SHD3ABP-313606-22– 334 residential units of which 118 will be Build to Rent (BTR) residential units, 4 retail/café/restaurant units and 3 commercial spaces associated with 3 live-work units, and a Childcare facility (144sq.m)

South Dublin County Council hereby sets out its Chief Executive's Report, including recommendations on the above Strategic Housing Development for An Bord Pleanála (ABP or The Board). The Board as the competent authority will carry out an Appropriate Assessment Screening of the proposed development and will decide to grant or refuse permission for the proposed development.

ABP-303306-18 Masterplan Statement Extract. Interface with subject site shown in red.

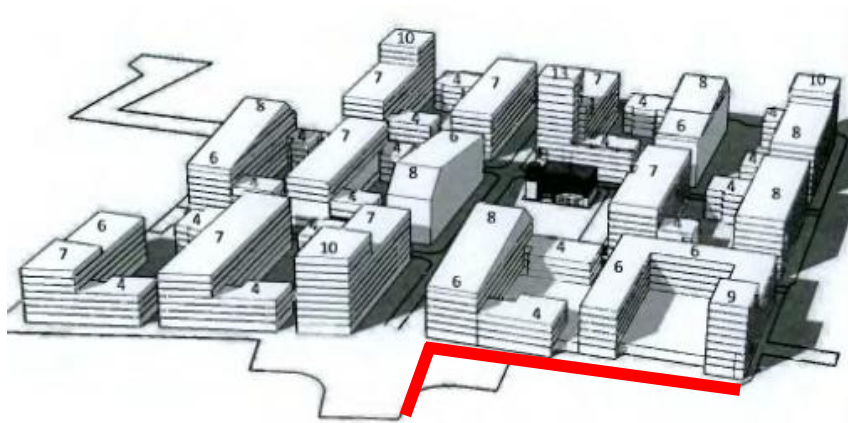
As noted at Stage 2, the criteria in section 2.6 relate to transport frequency among other measures. A limited uplift in height to match tower elements in the Marlet site (ABP-303306-18) could be justified on this basis. Such an uplift would allow for a 9-storey element at the north-east corner of the subject site, and a 10-storey element at the north-west corner. Concerns are raised that the Marlet site has not commenced and may not come forward to be an existing building.

Figure 3 Waste set-down areas

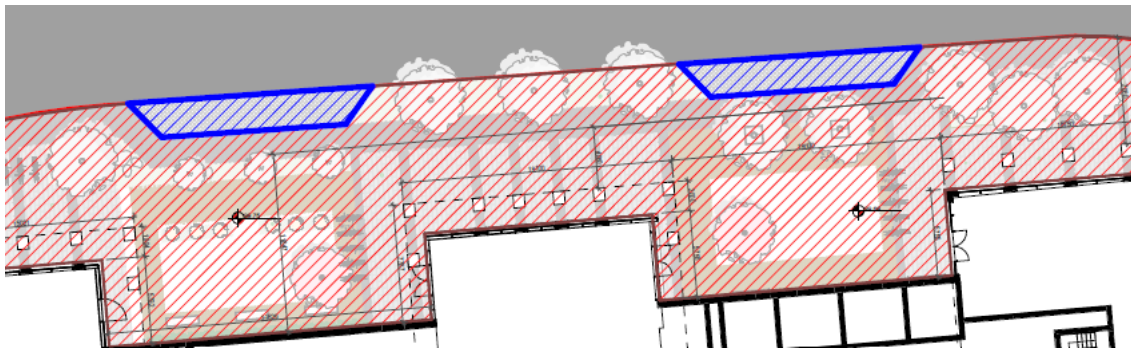
It is not acceptable to allow refuse collection from such a large-scale development from public road. It is most likely that the development will produce a significant amount of waste that will require 1100ltr containers. These containers will be placed in the public realm for collection.

The laybys shown outlined in blue on the taking in charge map should not be used to collect waste from the development. To retain these in the management companies' remit may lead to confusion for public parking. These areas are currently in public ownership and would need to be transferred to the management company.

Figure 4 Taking in Charge boundary

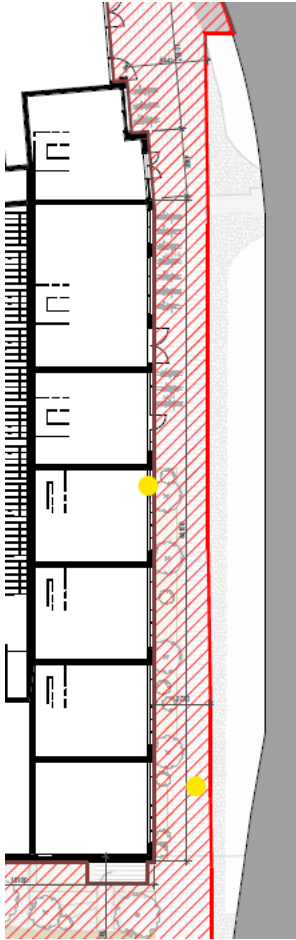
As shown in Figure 4 the taking in charge map supplied by the applicant the building line extends onto the public realm. The balconies and doorways along the east side of the development cross over into the public realm. Having balconies overhanging the public space is not acceptable and the build line should be reduced to accommodate the public space.
